Subject: 63-34160 – Application for Amendment for Licensing Purposes

RE: Water Right Permit No. 63-34160

SUBJECT: Licensing Review of Water Right 63-34160

STATE OF IDAHO
DEPARTMENT OF WATER RESOURCES
BENEFICIAL USE FIELD REPORT

Permit 63-34160
BUFE Topo Map

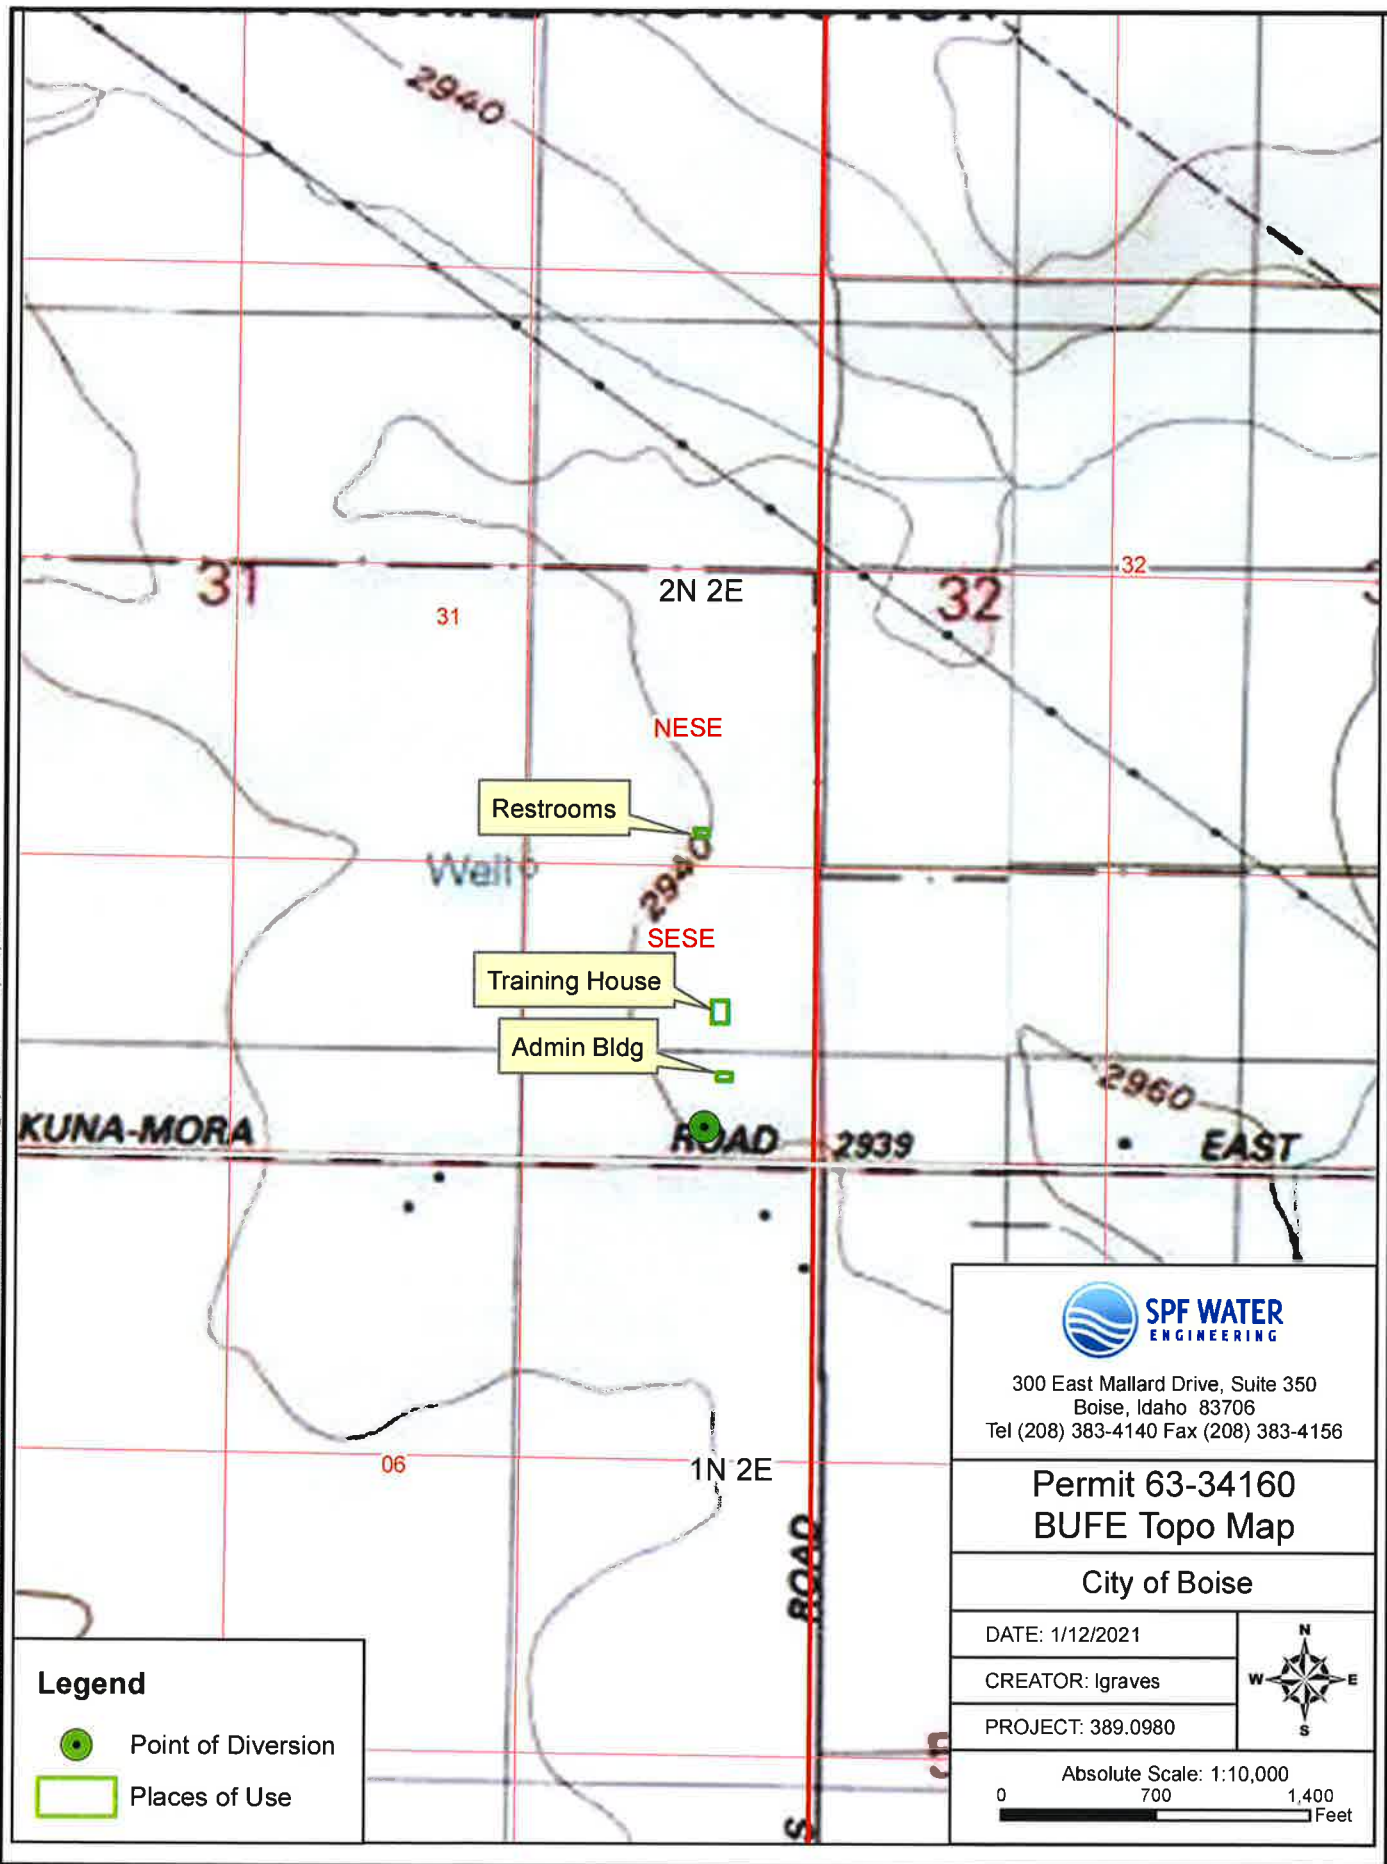
The field report submitted by Scanlan states that place of use for this permit was developed in the NE $\frac{1}{4}$ SE $\frac{1}{4}$ and SE $\frac{1}{4}$ SE $\frac{1}{4}$ of Section 31 in Township 2 North, Range 2 East. The permit states that the place of use was to developed in the SE $\frac{1}{4}$ SE $\frac{1}{4}$ of Section 31 in Township 2 North, Range 2 East.

I also agree that an amendment is needed to cover the actual place of use, since one of the bathrooms was actually in the NESE of Section 31. I didn't try to exactly match the place of use shape file for the domestic use that was provided by Mr. Scanlan, because I wanted to include the entire footprint of the facility not just the areas using water. I also used the point of diversion location that was GPS'ed in from the Well Driller's Report.

An amendment is required to add the satellite restroom building to the authorized place of use.

If the legal description on the permit does not match the legal description developed, then an amendment of the permit is required prior to licensing the permit. Therefore, an amendment is required to change the point of diversion on the permit before we can move forward with licensing the water right permit 63-34160.
